**Circular No. 216/2022**

**Field Safety Corrective Action of Philips Laser System (LAS-100) from Spectranetics Corporation**

## URGENT Field Safety Notice

Philips Laser System (LAS-100) with software version number 0.5.0.3

Figure 1: Example of an Error 106 visual alert

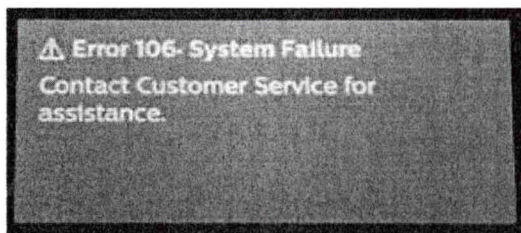
Philips has identified an intermittent software issue with the LAS-100 Philips Laser Systems. For affected units, having software version 0.5.0.3, the system may detect an error that will visually alert the user on the system display as "Error 106 – System Failure" or "Error 108 – System Failure" as described below:

- Error 106 is triggered when the actual ratio of energy between the Prism Energy Sensor (PES) and Vessel Energy Sensor (VES) differs from the expected (calculated) ratio (this is also known as sensor mismatch error), and in all complaints, Error 106 is triggering under conditions where it should not trigger (false positive).
- Error 108 is triggered when the PLS detects that 10 or more of the last 100 pulses were invalid (missing), and in all complaints, Error 108 is triggering under conditions where it should not trigger (false positive).

Philips internal testing confirms that the following steps may temporarily resolve the issue, if encountered:

1. System restart
2. Recalibration of the catheter in use or calibration of a new catheter
